Journalnummer: 2010-613/732

Projektet "Det Gamle Magasin", bliver ikke bygget ifølge tegningerne som byggetilladelsen er baseret på.

**Sunke side 5-1.jpg**

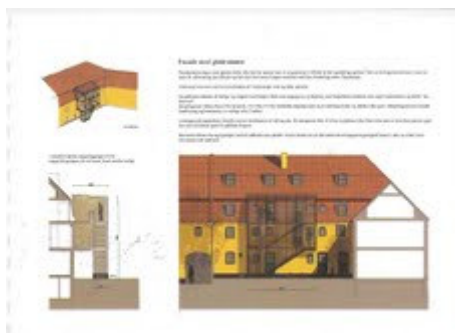
- Der er kun gjort klar til én dør i den nederste mansard hvor der skulle være 2. I samme etage er der ingen tagvinduer. Dette er ikke ifølge tegningerne.
- På første sal er der bygget 2 store vinduer i stedet for 2 sæt af 2 små vinduer.
- Der er gjort klar til en dør umiddelbart op mod muren mod øst i stueetagen. Dette er heller ikke ifølge tegningerne.

Vedhæftet er den tegning af nordfacaden som byggetilladelsen er baseret på.
